DATE: November 6, 2025
REF: SUP25-0033

FROM: Toledo City Plan Commission, Lisa Cottrell, Secretary

SUBJECT: Special Use Permit for Washington Local Schools Operations Building at 2162 W. Alexis Road

SITE PLAN

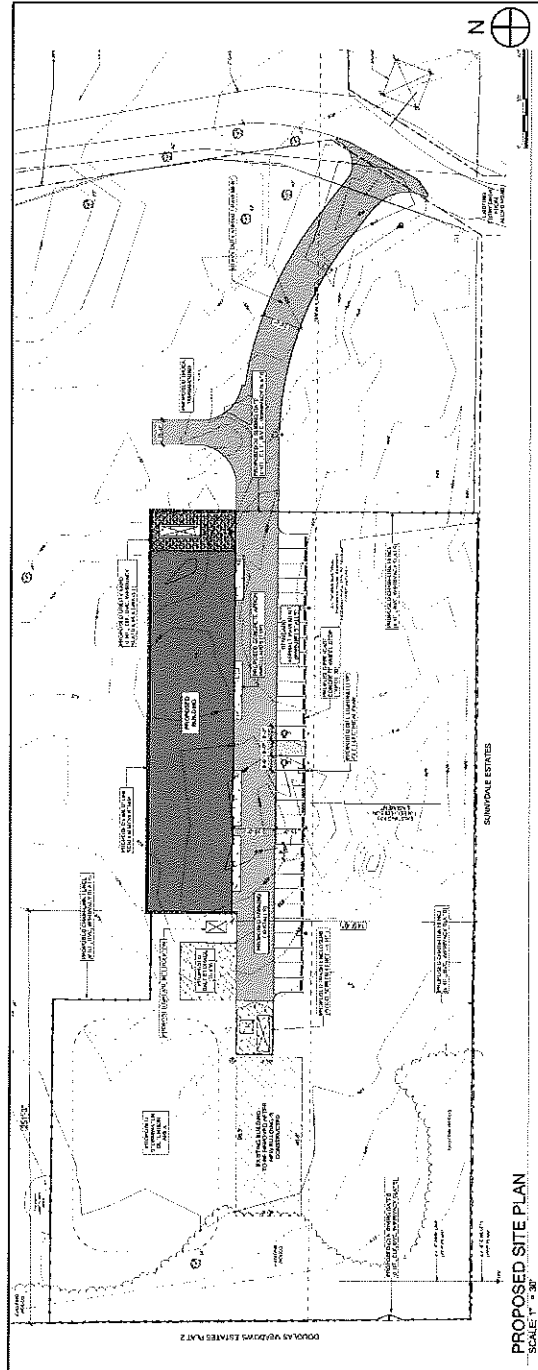
An asphalt drive and parking area will be constructed from the existing drive to Alexis Road for access to the proposed operations building. WLS has an access easement agreement to utilize the existing drive to Alexis Road. Based on the uses proposed for the building, a maximum of thirty-one (31) parking spaces are permitted. Thirty (30) parking spaces with wheel stops are proposed; therefore, the proposal meets the maximum off-street parking space requirements of Schedule A in TMC§1107.0304, and the requirement for wheel stops in TMC§1107.1907. Based on the thirty (30) proposed parking spaces, three (3) bicycle parking slots are required. No bicycle parking slots are provided; therefore, the site plan shall be revised to show the required bicycle parking slots and listed as a condition of approval.

Accessible off-street parking is required per TMC§1107.1700 at a rate of one (1) car-accessible and one (1) van accessible parking space, when there are twenty-five (25) to fifty (50) total parking spaces. The proposed site plan meets this requirement as two (2) van accessible parking spaces are provided.

33. Bicycle parking is required per TMC§1107.0900.
34. Accessible parking must be the closest parking space to the accessible entrance for the shortest path of travel per Americans with Disabilities Act and TMC§1107.1703.
35. Stripe a cross-walk from accessible parking loading aisle to the front entrance.

38. Further development of the site by WLS will require rezoning the property to IC Institutional Campus and submitting an IC master plan.
39. Three (3) bicycle parking slots are required based on the thirty (30) proposed parking spaces per Schedule A in TMC§1107.0304. **No bicycle parking slots are provided. Not acceptable as depicted. The required bicycle parking slots shall be provided and a revised site plan submitted.**

40. Two (2) accessible parking spaces are required per TMC§1107.1700. Two (2) van accessible parking spaces are provided. **Acceptable as submitted.**
41. A detailed site lighting, fencing and landscape plan (separate from building & site plans) shall be submitted to the Plan Director for review and approval. Such plan shall include:

LANDSCAPE PLAN

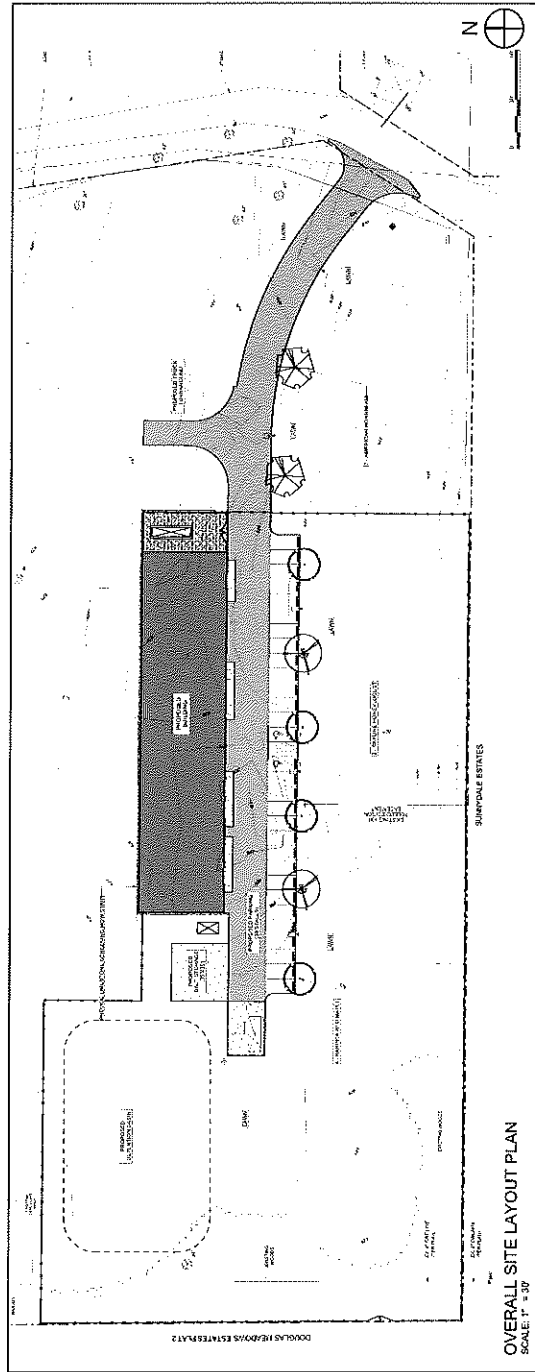
The submitted landscape plan shows that the existing wooded area along the west property line and a portion of the south property line will be retained in the area of the proposed development. In addition, a six-foot (6') high chain-link fence with privacy slats is illustrated on the site plan surrounding the proposed development. As noted previously, future development of the remaining site will require rezoning and submission of an IC master plan. This will require a Type "A" buffer along the property line of the subject property and abutting RS6 and RM36 zoning districts per TMC§1108.0203. A Type "A" buffer shall therefore be provided along the south and west portions of the submitted proposal as a condition of approval. This buffer shall be a minimum of twenty-five feet (25') in width with four (4) canopy trees per 100 linear feet. The existing woods as illustrated on the plan meets this requirement for the western property line and a portion of the

southern property line; however additional trees are required for the remaining portion of the southern property line where there is no existing woods. There is an existing 100' wide Toledo Edison Easement along the southern property line. The applicant has noted that Toledo Edison has indicated that trees and/or built structures taller than twenty feet (20') shall not be located within the easement because of the overhead power lines. Staff therefore supports not requiring the additional trees, based on the existing easement and the 100' setback that is in essence created by the easement, as well as the proposal to keep the existing wooded area. Shrubs are also required unless a fence, wall, or berm six feet (6') to eight feet (8') in height is provided. While a chain-link fence with privacy slats is proposed, chain-link fencing is not permitted to be used to meet buffers and screening requirements per TMC§1108.0404(B). Therefore, a privacy fence shall be installed instead of the proposed chain-link fence with slats. Due to the overall size of the site, required fence installation will be phased, at the discretion of the Plan Director, based on proposed areas to be developed. These landscape buffer requirements are listed as a condition of approval.

Interior parking lot landscaping is also required at a rate of two (2) canopy trees and six (6) shrubs for each ten (10) parking spaces per TMC§1108.0204(C). Therefore, six (6) canopy trees and eighteen (18) shrubs are required. Eight (8) trees are illustrated on the landscape plan. Eighteen (18) shrubs are still required. Due to the nature of the site, the open green space provided by the Toledo Edison Easement, and the requirement for a privacy fence, the need for the required shrubs is mitigated. Staff recommends that the interior parking lot landscaping be at the discretion of the Plan Director and listed as a condition of approval.

- a. A Type "A" landscape buffer shall be provided along the south and west portions of the submitted proposal where the abutting property is residentially zoned. The existing woods meet this requirement where noted. Additional trees are not required for the remaining portion of the southern property line where there is no existing woods based on the existing easement and the 100' setback that is in essence created by the easement, as well as the proposal to keep the existing wooded area. Additionally, in lieu of the required shrubs, a privacy fence shall be installed. Due to the overall size of the site, required fence installation for the site will be phased at the discretion of the Plan Director. **Not acceptable as depicted. A privacy fence shall be installed.**

- b. Interior parking lot landscaping in the amount of six (6) canopy trees and eighteen (18) shrubs are required per TMC§1108.0204(C). Eight (8) trees are illustrated on the landscape plan. Due to the nature of the site, the open green space provided by the Toledo Edison Easement, and the requirement for a privacy fence, the need for the required shrubs is mitigated. **Required interior parking lot landscaping shall reviewed and approved by the Plan Director.**

- h. The location, height and materials for any fencing to be installed and maintained. **Not acceptable as depicted. A privacy fence shall be provided instead of the proposed chain-link fence with slats.** As noted in Condition 40(a), due to the overall size of the site, the required fence installation will be phased at the discretion of the Plan Director.

ELEVATIONS

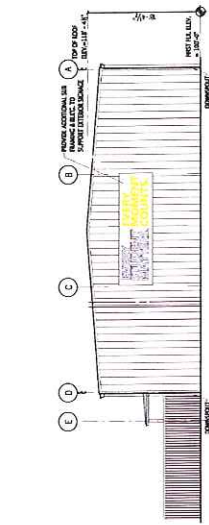
Two building signs are illustrated on the submitted building elevations. One is a panther paw and the other is a sign with words that look to be part of the WLS Mission and Vision Statements. While building signs are permitted in the RS6 zoning district for which the area of the subject property to be developed is zoned, building signs are limited in size based on building wall frontage that faces a public street per TMC§1113.0303. The building is not on a public street; therefore, zero (0) square footage of building signage is allowed. A variance would need to be secured from the Board of Zoning Appeals (BZA) to permit building signage. Section 1113.0500 Special Sign Types does however permit address identification signage, directional signage, and internal signage per TMC§1113.0502, TMC§1113.0505, and TMC§1113.0508 respectively. Any signage proposed shall meet the sign code in Chapter 1113 Signs. These are listed as a condition of approval.

42. Salt storage building elevations/details shall be submitted to determine compliance with the design standards in Chapter 1109.
43. Zero (0) square footage of building signage is allowed per TMC§1113.0303. A variance shall be secured from the BZA for any building signage. Address identification signage, directional signage, and internal signage is permitted per TMC§1113.0502, TMC§1113.0505, and TMC§1113.0508 respectively. Any proposed signage shall meet the sign code in Chapter 1113 Signs and a sign permit shall be secured.
